43-069 - DPF Regeneration Two-Position Switch Parameter Update

43-069

DPF Regeneration Two-Position Switch Parameter Update

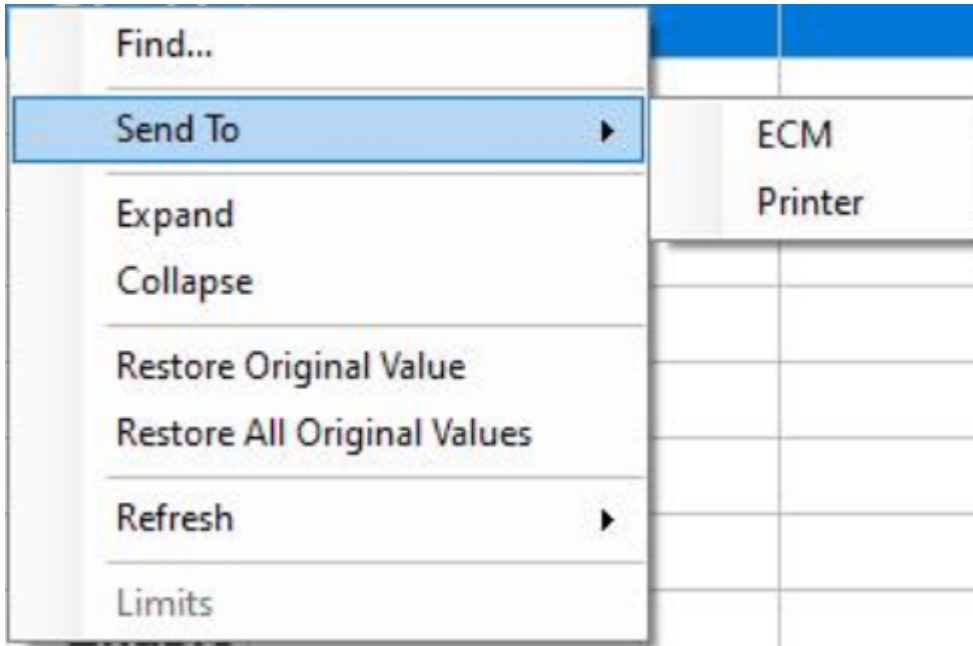
A DPF regeneration two-position switch parameter is causing inhibited DPF regeneration. A parameter update, via Cummins Insite, restores proper DPF regeneration function.

1. Connect to the truck with Cummins Insite.
2. Select **Features and Parameters** and locate the parameter named *Diesel Particulate Filter Regeneration Permit Switch*.

3. Set the status to **Disable**.
